## MEMORANDUM

Subject: 19 Roszel Road, LLC  
Sign Waiver Request  
Block 9 Lot 62  
19 Roszel Road

**SUBJECT:** 19 Roszel Road  
Sign Waiver Request  
Comment Review Memo #1  
PB 20-02SW  
Block: 9, Lot: 62  
West Windsor Township, Mercer County, New Jersey

Map 1: Subject Site (scale: 1" = 300')

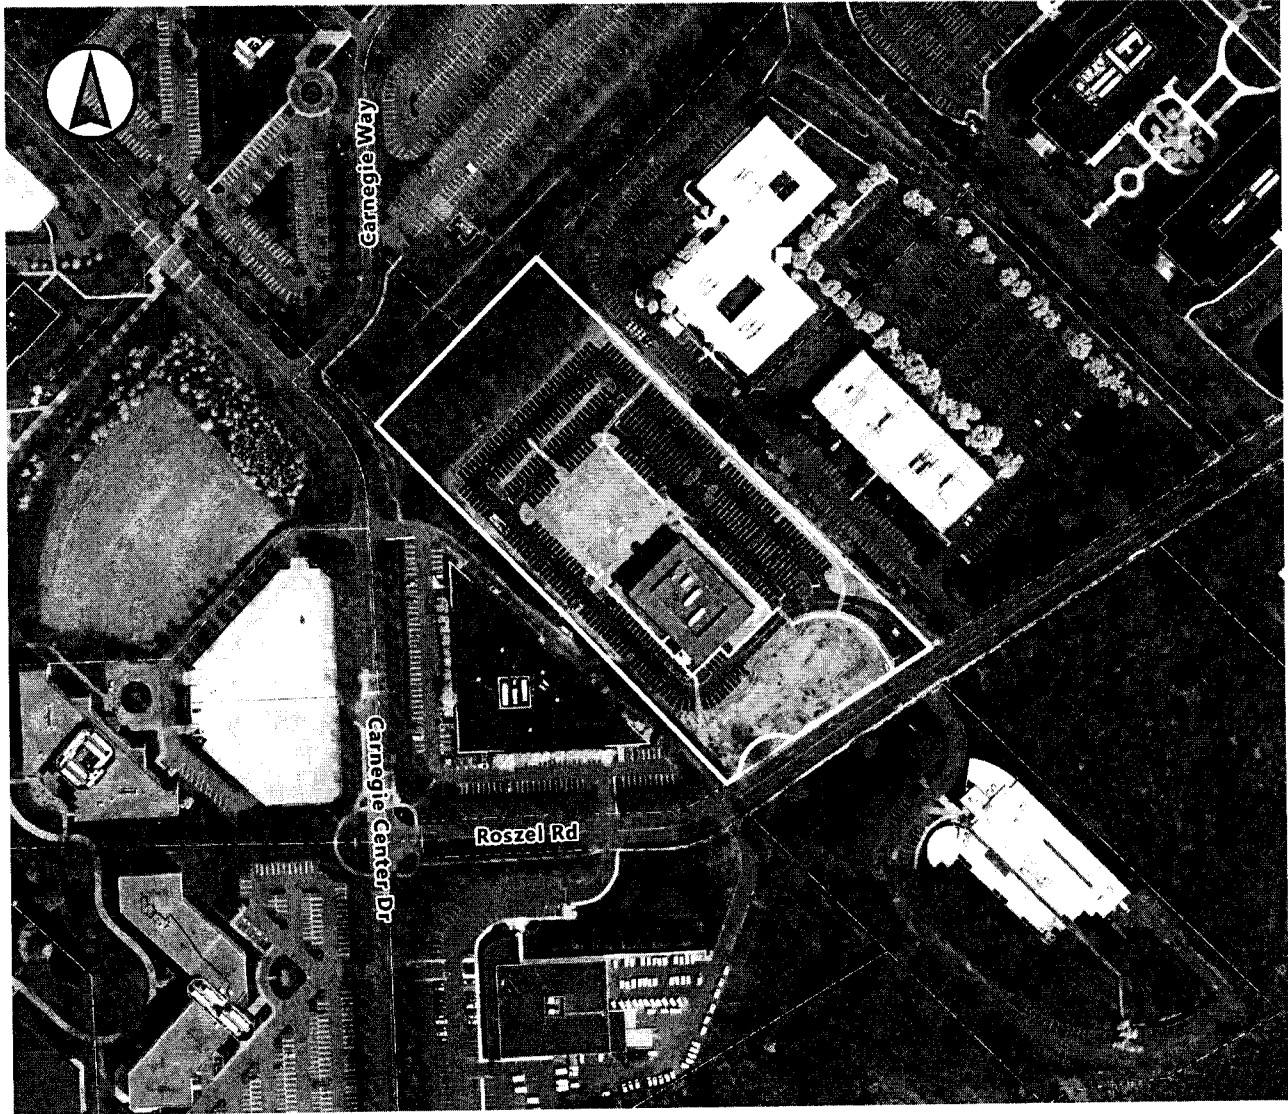
4. Location of Approved Building. The applicant and the Board should discuss the location of the approved but not yet constructed office building and how it relates to both the existing building and the street right-of-way. We note that the approved but not yet constructed building is approximately four hundred and sixty (460) feet away from the property line. For reference, the ROM-2 District requires a front yard setback of one hundred and twenty-five (125) feet. It is also partially obscured by the existing building located in front of it.
5. Monument Sign. Testimony should be provided as to whether the second additional building will also be advertised on the monument sign.
